SB-10057385-5121

BRT: Support Bracket Addition between Wiper Motor

Mounting and Idler Bracket

Property name and Top bus number: 42 and 60BRT buses

611-2639-003

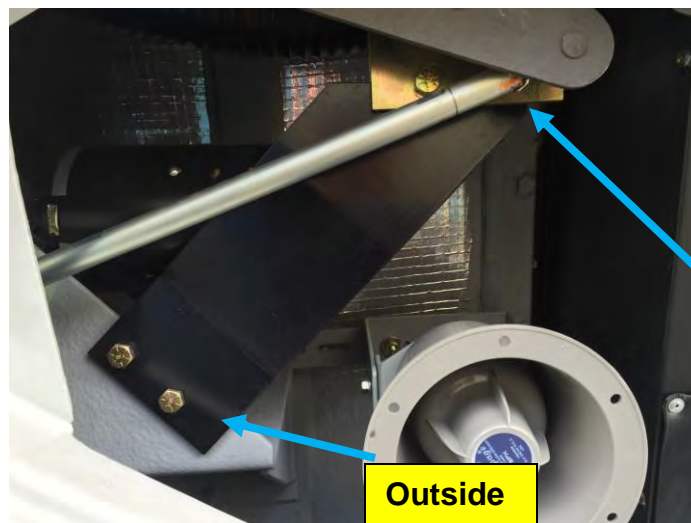
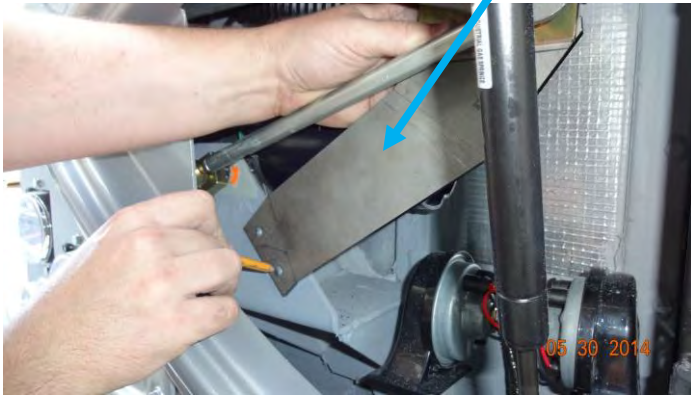
Issue: Under certain operating conditions, the wiper blades may over travel and overlap A-post windshield rubber at highway speeds when the wipers are on high.

Reason/ cause: There are multiple reasons: Worn linkage rod end bearings and/or incorrect linkage adjustment which may also cause the wiper motor mounting bracket to flex.

4. Line up support bracket PN 611-2639-003 to mark pilot holes. Drill holes with a 3/16 drill bit to start with, then use a 5/16 drill bit for the final holes. Mount support bracket using 5/16 hardware as listed above. Ensure that the bottom of the support bracket is mounted outside of the wiper mount and the top of the bracket mounted inside the intermediate bracket as photos shown below.

Inside

Outside
